**City of Mt. Vernon
Planning and Zoning Commission
February 26, 2025 6:30 PM
City Hall, 213 1st Street NW**

MEETING PACKET

1. Call to Order / Roll Call
2. Approval of Agenda
3. Approval of Minutes – January 2, 2025 and January 22, 2025
4. Public Discussion: Items not on the agenda. Each citizen is limited to 5 minutes
5. Final Plat – Stonebrook 10th Addition
6. Adjournment

**FINAL PLAT
STONEBROOK 10TH ADDITION**

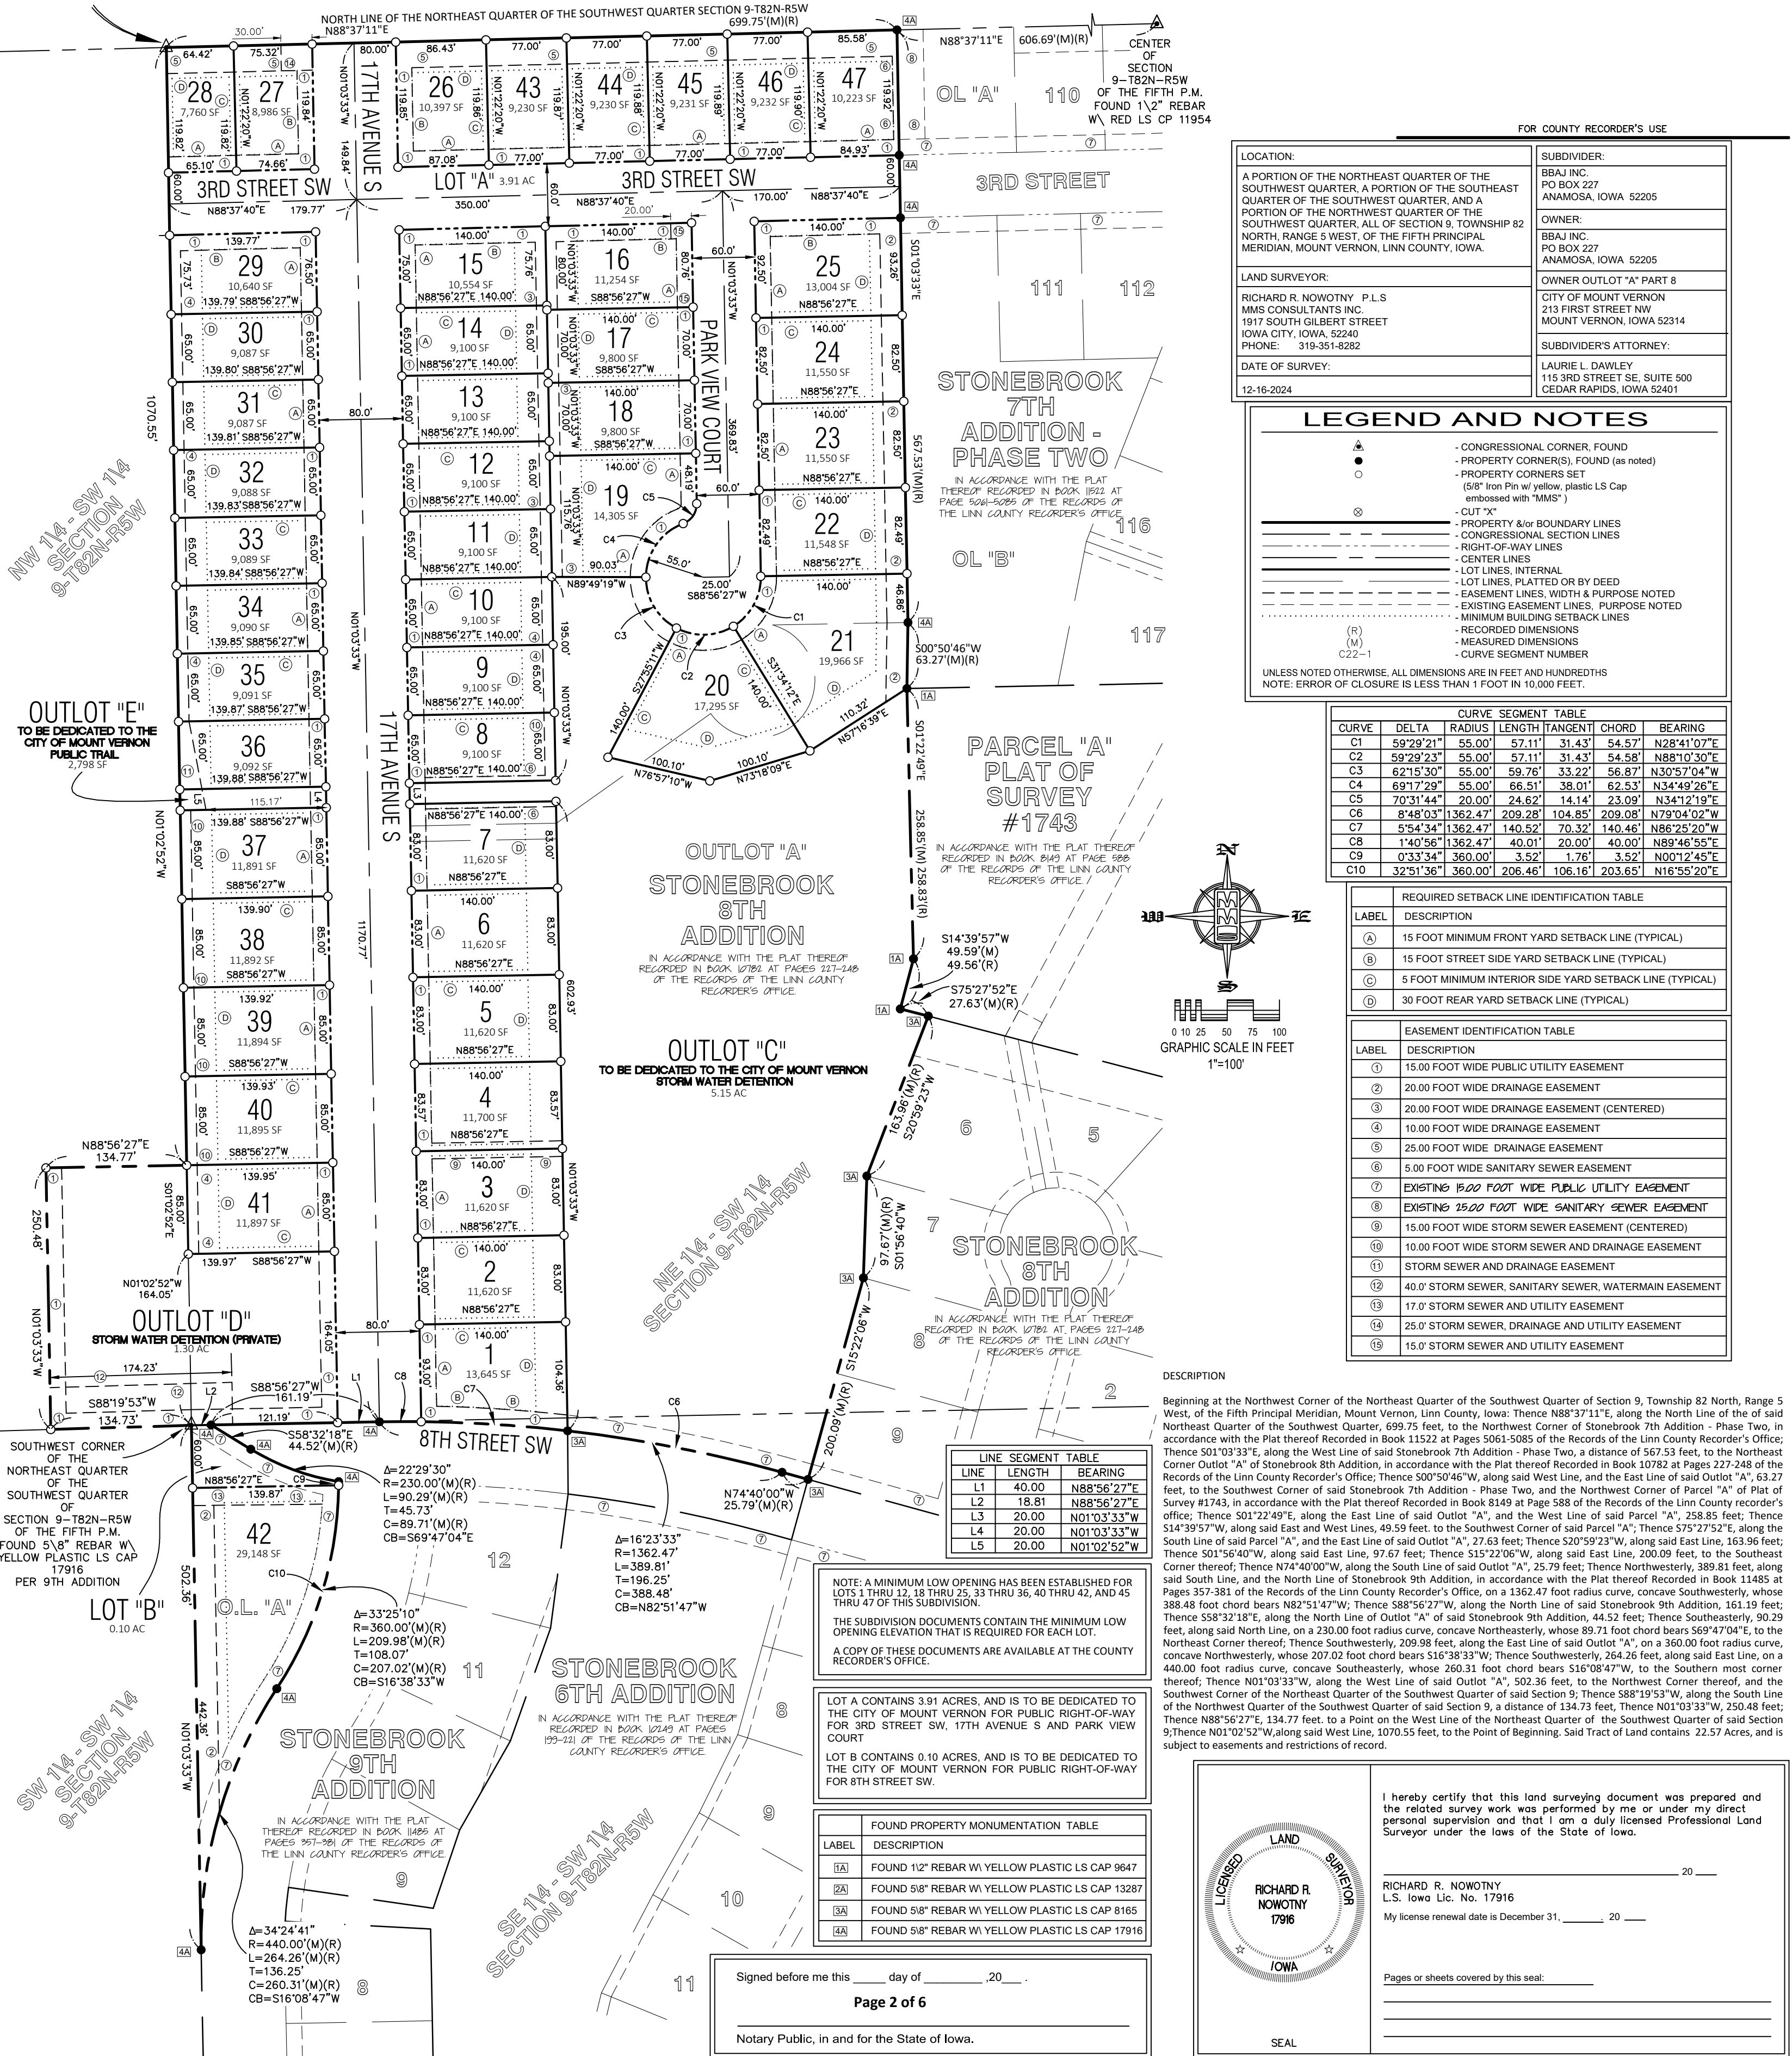
City Engineer Dave Schechinger has completed his review of the public improvements and recommends them for acceptance. The developer has agreed to set aside an escrow amount of \$27,176 for the following items:

- ADA Ramps on 8th & 3rd Avenues
- Postal Pads in front of Lots 37 and 46
- Final work on stormwater intakes
- Grading around the 3rd box culvert

Lots A and B are dedicated to the City for public right of way.

Lot B includes a section of 8th Street to allow inclusion of Lot 42 in the plat. This parcel was previously designated as an outlot on the Final Plat of Stonebrook 9th Addition and will now be available for development.

Outlot C is a stormwater management area that has been reconfigured from its original design as Outlot A on the Stonebrook 8th Final Plat. The capacity of the area remains the same, but a Quit Claim Deed is required for sections of Lots 20 and 21 to prevent future concerns with title searches on those parcels.

Outlot D is being reserved by the developer for stormwater management.

Outlot E of the 10th Addition is dedicated to the City for provision of a mid-block trail on the east and west-facing blocks along 17th Avenue. This satisfies local design standard 166.12(D), which requires pedestrian-ways near the center of blocks in excess of 600’.

¹ Of minor note, the trail section north of Lot #7 of the 10th Addition, has been relocated slightly to the north of the original location identified on the Final Plat for Stonebrook 8th.

Staff recommends approval of the Final Plat at this time.

Revised Prelim. Plat – Approved April, 2024.

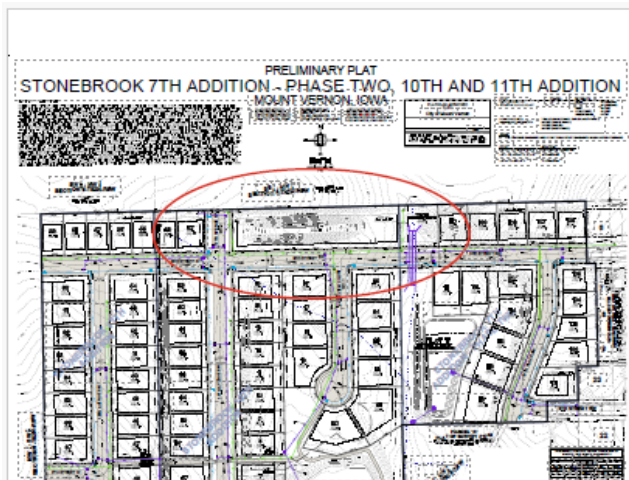
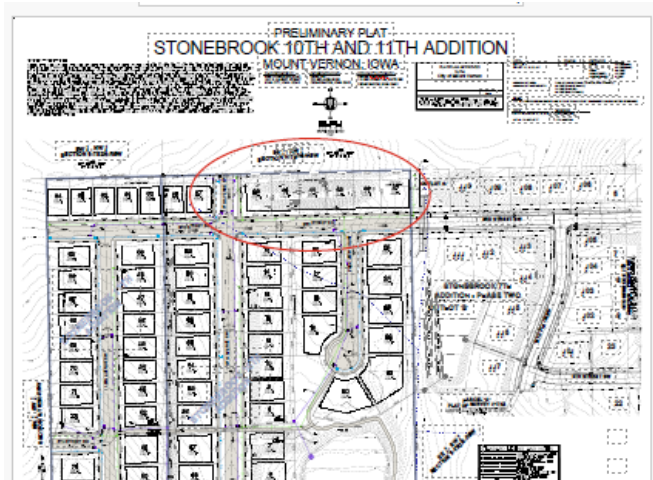
In April, 2024, a revised Preliminary Plat for Stonebrook 10th-11th Additions was approved, reallocating 1.32 acres of Lot #26 as six (6) residential lots.

PRELIMINARY PLAT STONEBROOK 7TH ADDITION - PHASE TWO, 10TH AND 11TH ADDITION MOUNT VERNON, IOWA

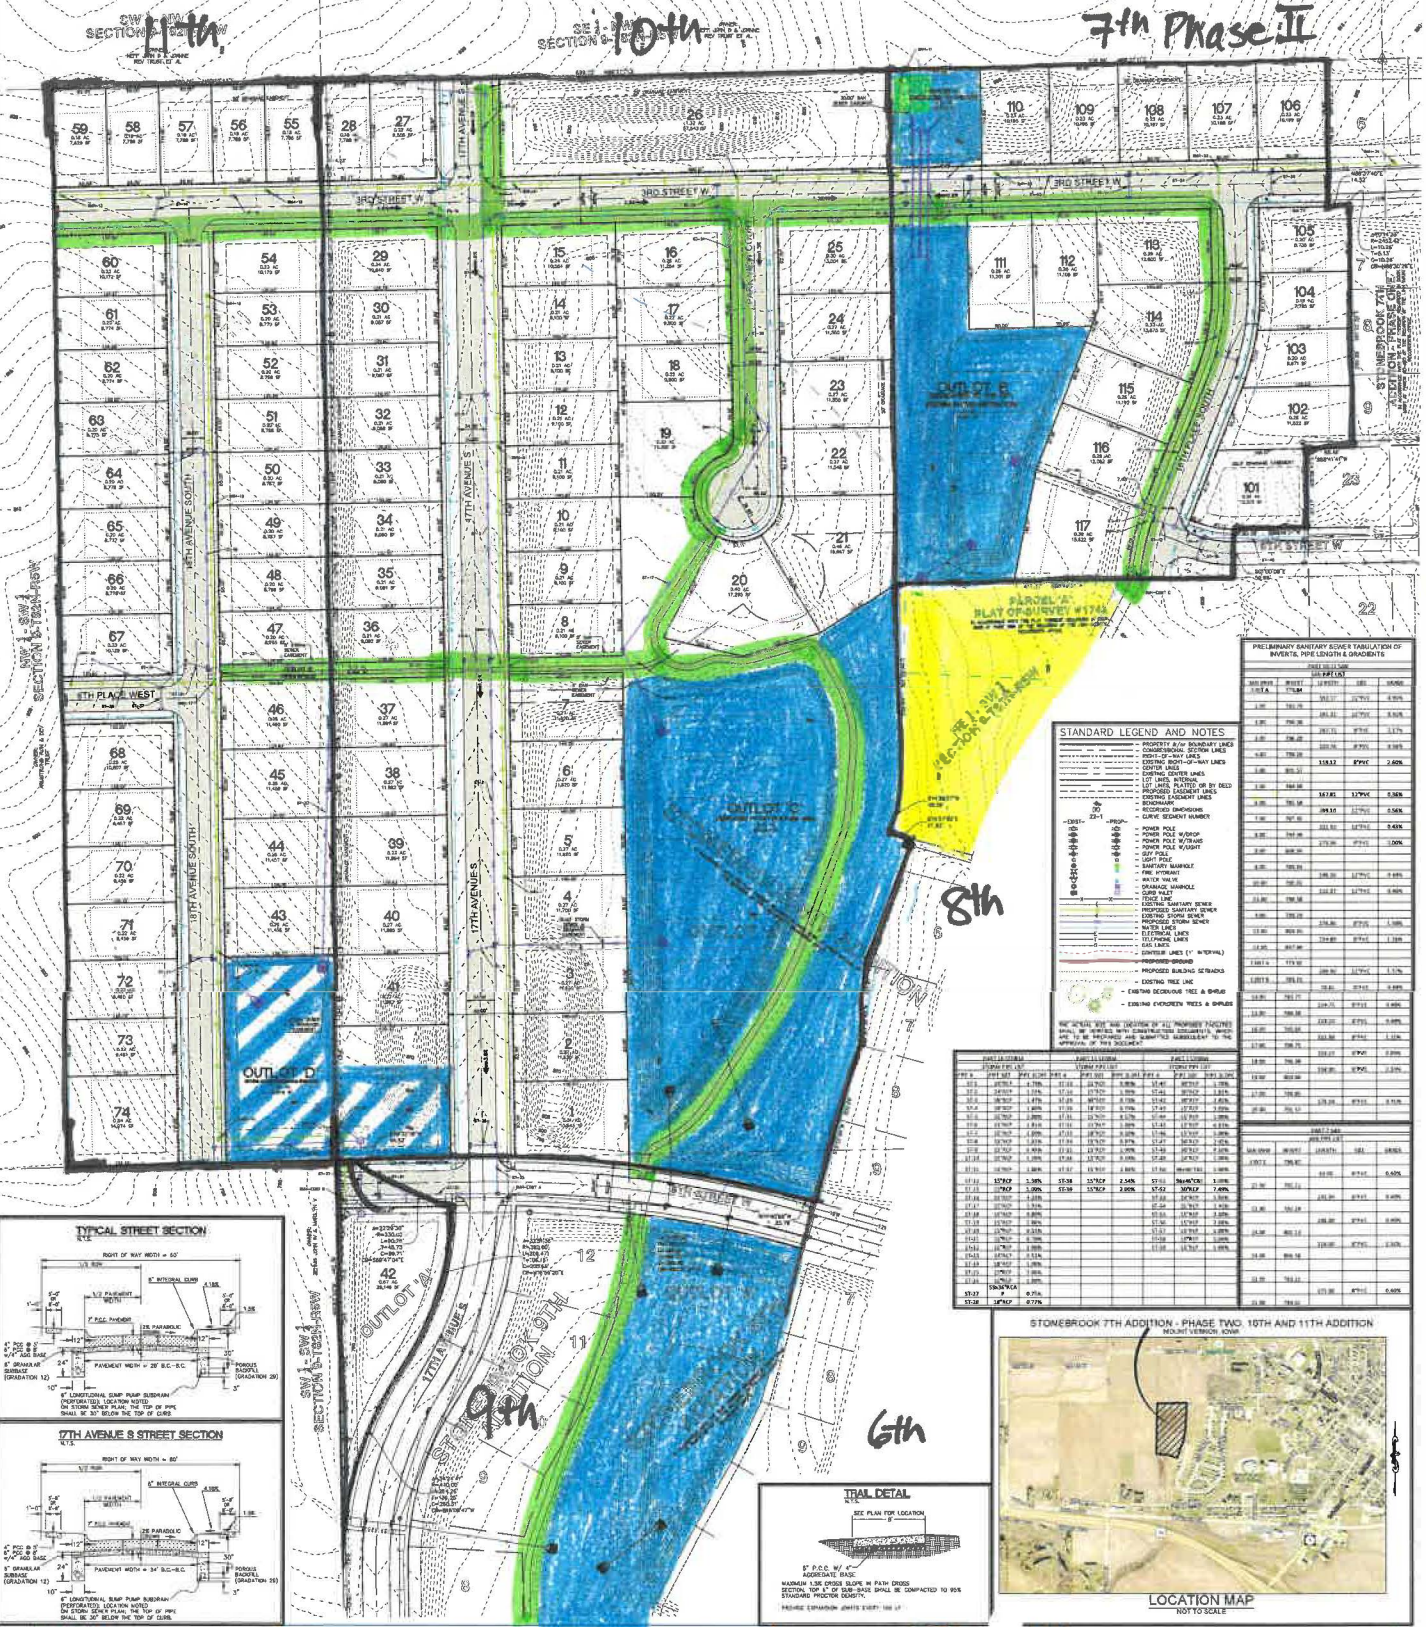
There is substantial trail-width paving in this addition, as illustrated on the following page (See *Stonebrook 7th Addition – Phase Two, 10th and 11th Addition*).¹

Other trail sections provide interconnectivity with other phases of this development and/or border stormwater management areas that will remain undeveloped.
